Access Compliance Report

Public Rights-of-Way

(Curb Ramps)

Intersection ID: 31486	Main Street: CLOVER_GAP_DR	Cross Street: ELISE_MARIE_DR	Location: E
ADA ID: 9713FC30C6B9	Ramp Type: Perp	Initial Pass/Fail: Fail	Overall Compliance: No
Codes/Mitigation Info/Possible Solution		Field Measurements/Component Compliance	
Severity Score: 8.75

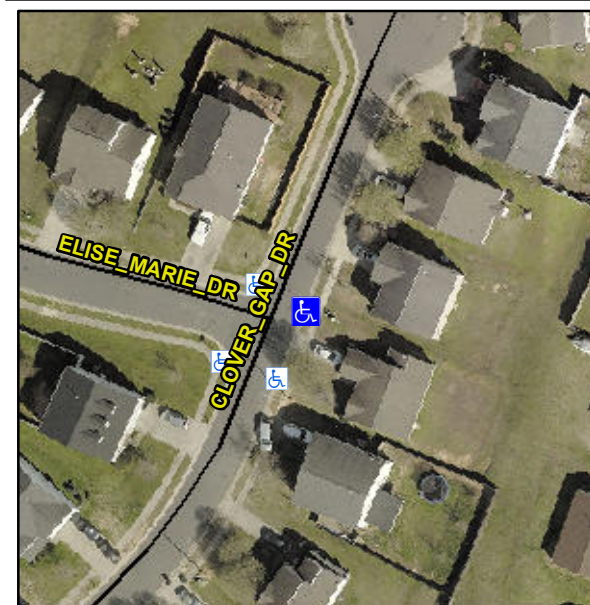
Not Found, R304.5.1

Compliance	Description	Data	Compliance	Description	Data
N/A	Ramp Length (in)	48.0	Yes	Ramp Slope (%)	8.1
No	Ramp Width (in)	45.0	Yes	Ramp XSlope (%)	0.4
N/A	Flare Type LT	N/A	N/A	Flare Type RT	N/A
N/A	Flare Slope LT (%)	N/A	N/A	Flare Slope RT (%)	N/A
N/A	Flare Traversable LT?	N/A	N/A	Flare Traversable RT?	N/A
N/A	Landing Length (in)	N/A	N/A	DWS Provided?	N/A
N/A	Landing Width (in)	N/A	N/A	DWS Contrast?	N/A
N/A	Landing Slope (%)	N/A	N/A	DWS Length (in)	N/A
N/A	Landing X Slope (%)	N/A	N/A	DWS Full Width?	N/A
N/A	Landing Curb? (Y/N)	N/A	N/A	DWS Offset (in)	N/A
N/A	Shared Landing?	N/A			
N/A	Gutter Ponding?	N/A	N/A	Gutter Slope (%)	N/A
N/A	Gutter Lip Ht (in)	N/A	N/A	Gutter X Slope (%)	N/A
N/A	Painted X Walk1?	No	N/A	Painted X Walk2?	N/A
	X Walk 1 Direction	To NW		X Walk 2 Direction	N/A
N/A	X Walk 1 Width (in)	N/A	N/A	X Walk 2 Width (in)	N/A
	X Walk 1 Slope (%)	3.1		X Walk 2 Slope (%)	N/A
	X Walk 1 X Slope (%)	0.6		X Walk 2 X Slope (%)	N/A

Remove & Replace Entire Ramp.
